APPENDIX I

Written Comments on the DEIS,
Community Board 5 and Manhattan Borough
President's Recommendations,
and Vornado Correspondence

15 Penn Plaza: CPC public hearing questions (5/26/2010)

15 Penn Plaza: Response to CPC Questions
(CPC Public Hearing: 5/26/2010)

ATTACHMENT 11

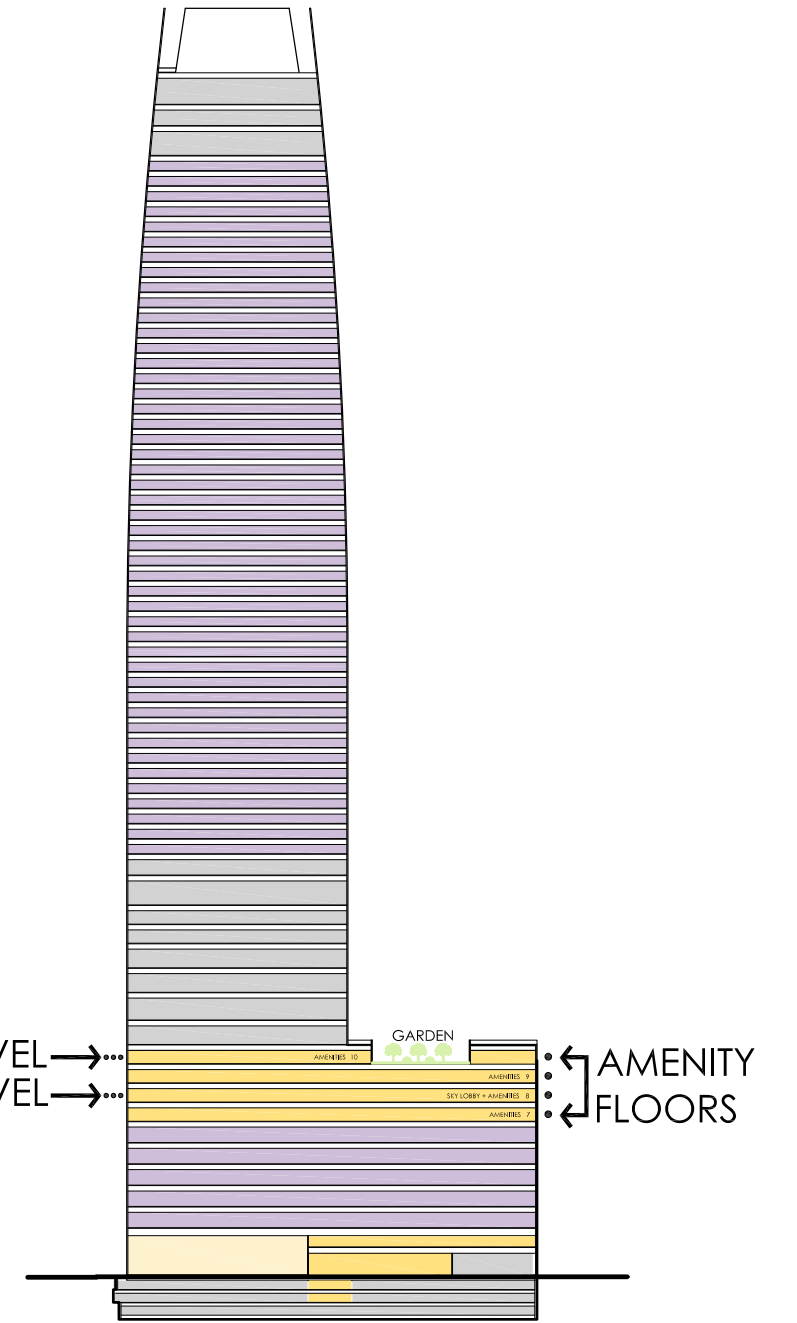
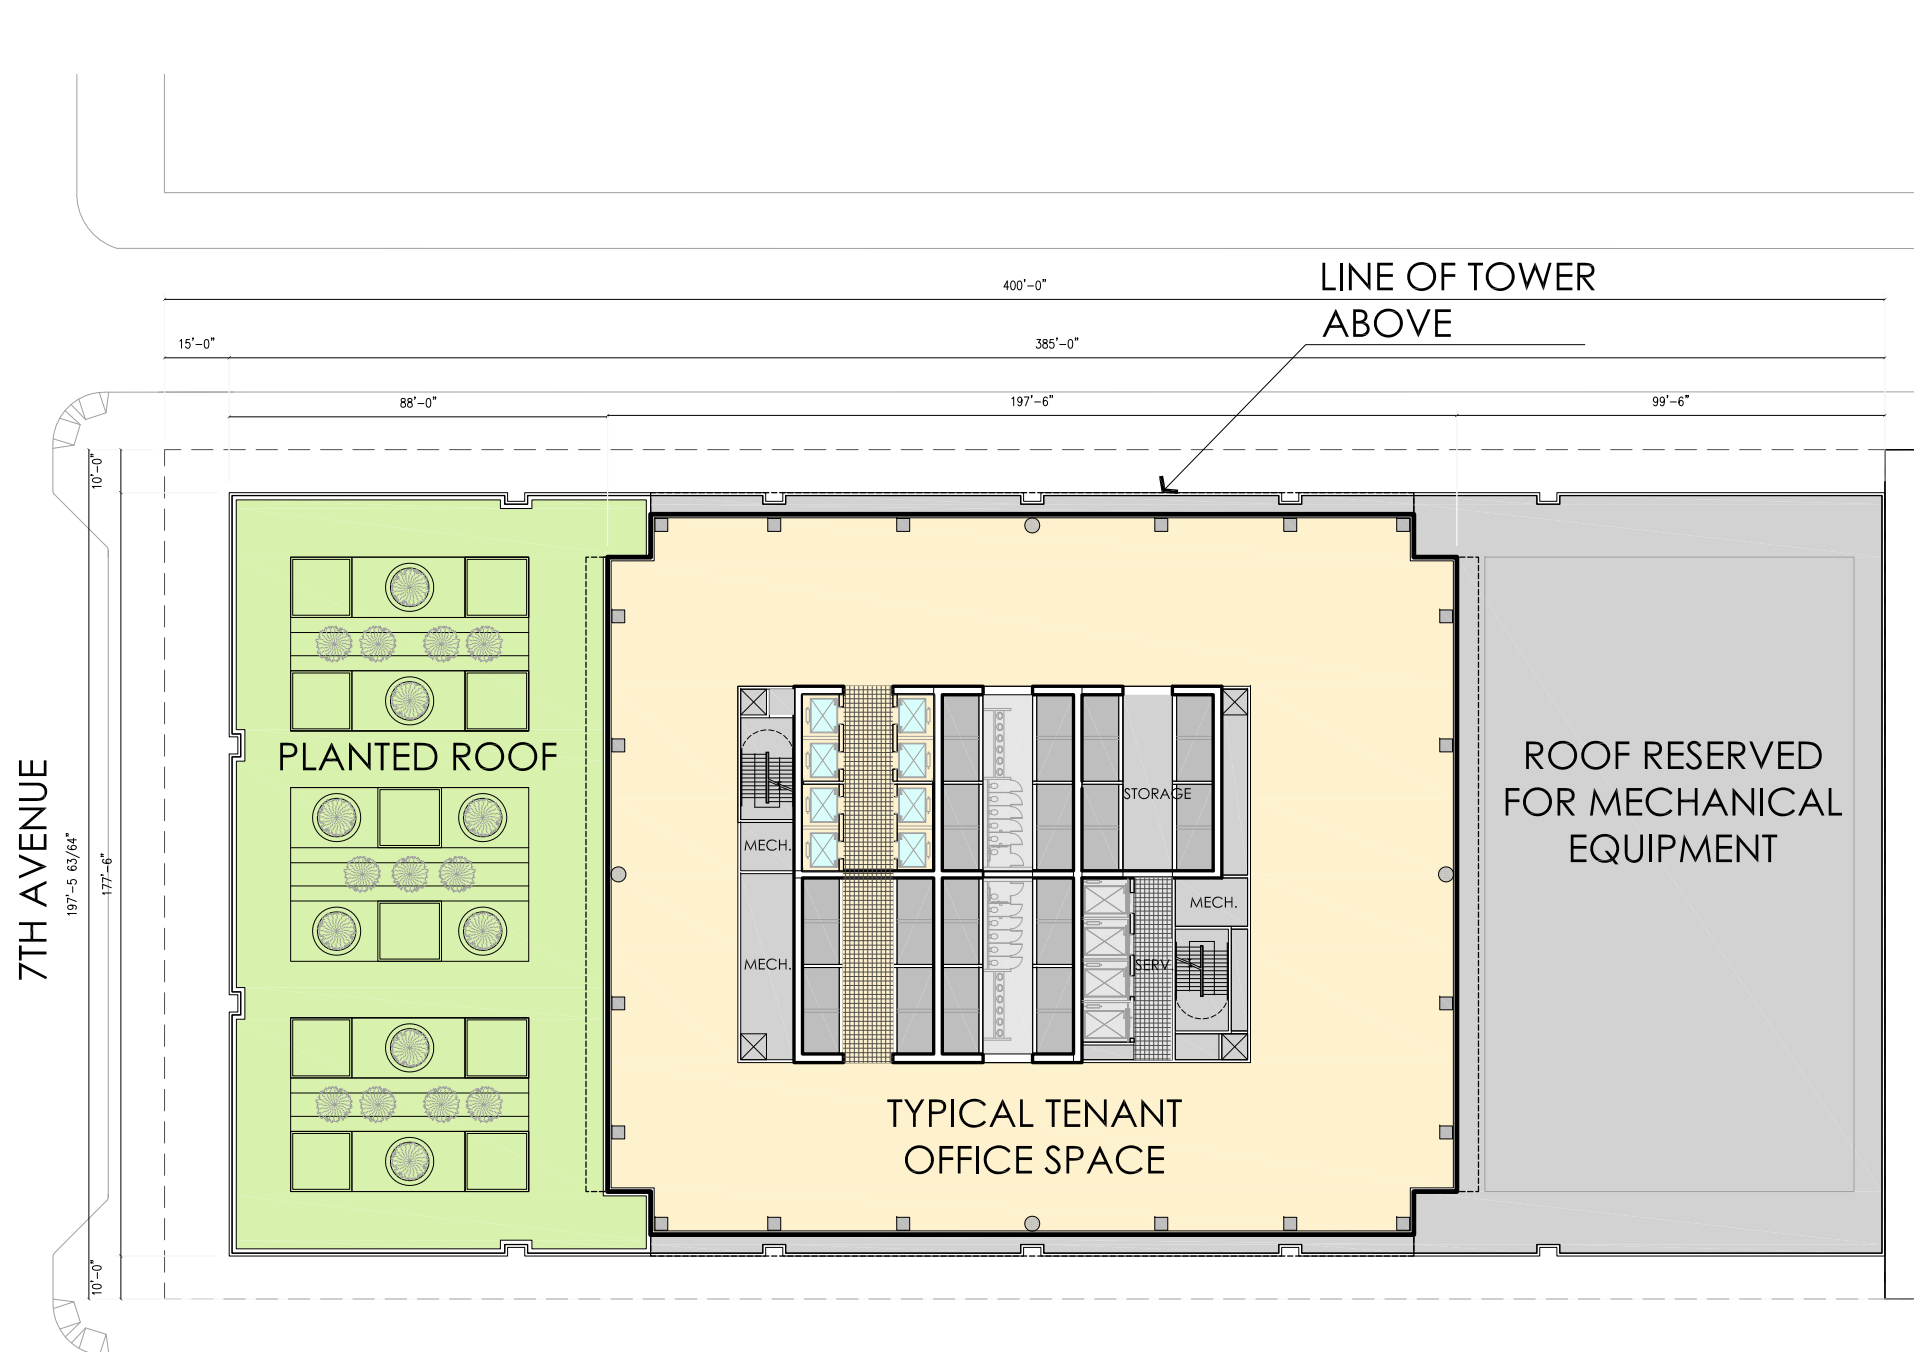
3. Podium roof plans

As requested, podium roof plans for the two buildings are shown in Attachments 11 and 12.

- The single-tenant podium roof will incorporate a garden as a tenant amenity. It will include shade trees, seating (with tables) and landscaping that complies with the design requirements for public plazas (Section 37-70). A detailed landscaping plan of this roof-top garden will be available next week.
- The multi-tenant podium roof has two components. On the western side, green-roof technologies will be employed. The eastern section of the podium will be reserved for mechanical space, including potential stormwater retention equipment.

GARDEN TO CONTAIN SHADE TRELLIS SEATING WITH TABLES AND LANDSCAPING THAT COMPLIES WITH PUBLIC PLAZA DESIGN REQUIREMENTS (SECT 37-70).
 DETAILED LANDSCAPING PLAN BEING COMPLETED.
